**Engineering Review**

**EPC Planning & Community  
Development Department**

**FINAL DRAINAGE REPORT**

**BLACK FOREST OFFICE  
The North Half of the NE Quarter of the SE Quarter of Section 7  
Township 12 South, Range 65 West of the 6<sup>th</sup> P.M.  
County of El Paso, State of Colorado  
12740 Black Forest Road  
Colorado Springs, Colorado 80908**

**PROPOSED BASIN MAP**

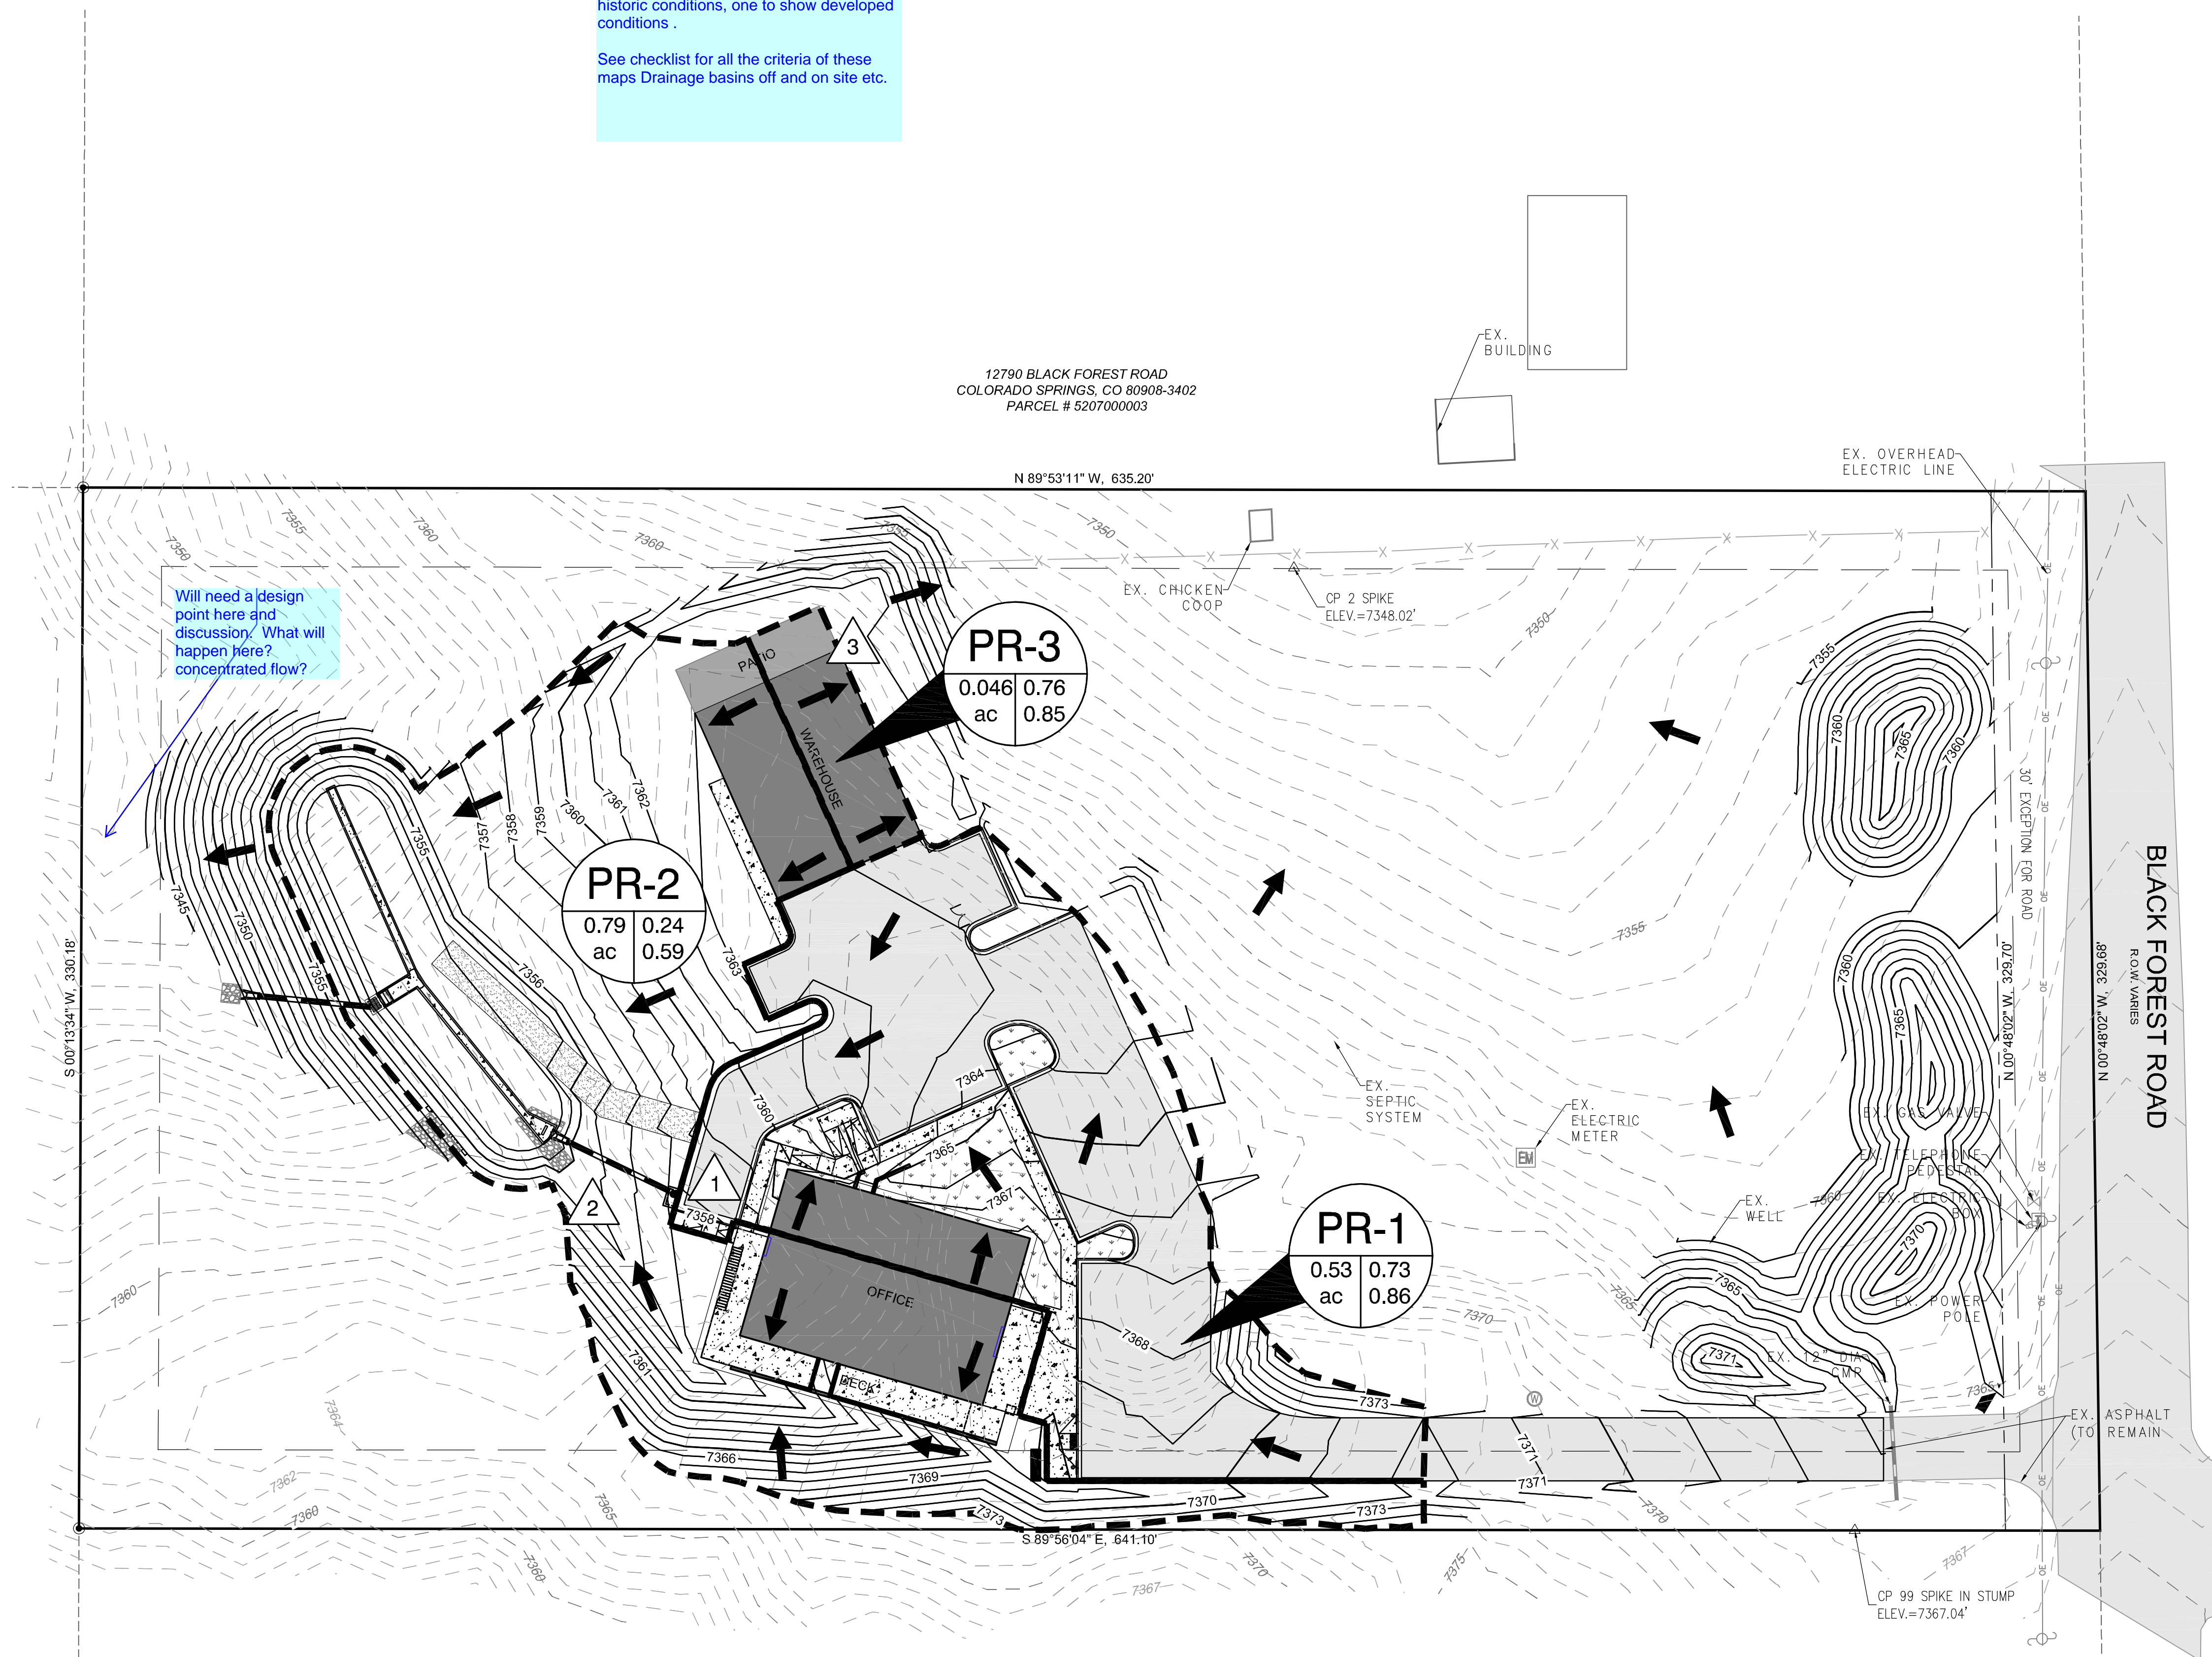
Provide two plan/maps; have them as the last pages of the report. One to show historic conditions, one to show developed conditions.

See checklist for all the criteria of these maps Drainage basins off and on site etc.

Provide design points with historic and developed flows to demonstrate the proposal. See checklist for further comments to for a complete submittal.
